Raspberry Pi 4 Model B

PCN 45 – Dual RAM variant

Update of Raspberry Pi 4 Model B (all variants) PCB to support dual DRAM modules.

Figure 1.
Front of board

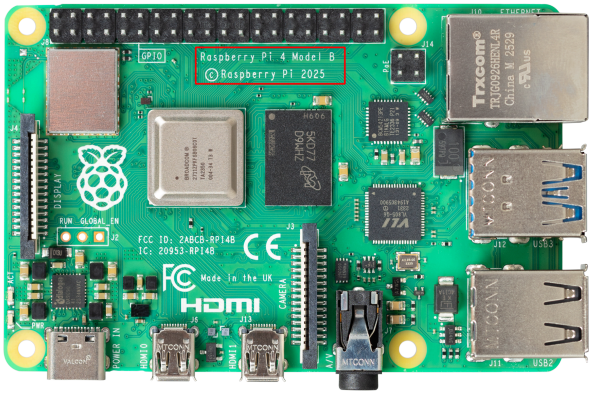
The new product can also be distinguished by examination. The new revision PCB has an additional RAM chip on the rear of the board and has the date 2025 silkscreened on the front of the board.

This revision of the PCB is designed for intrusive reflow manufacture so there may also be visible differences in the soldering.

Figure 2.
Rear of board

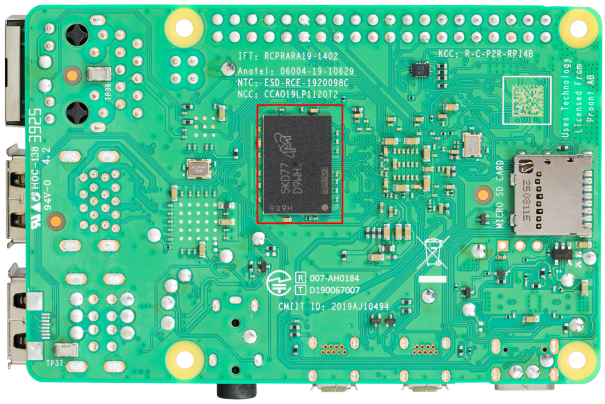
There is now a 2nd LPDDR4 device on the underside of the PCB and some small passive components have moved to accommodate this addition.
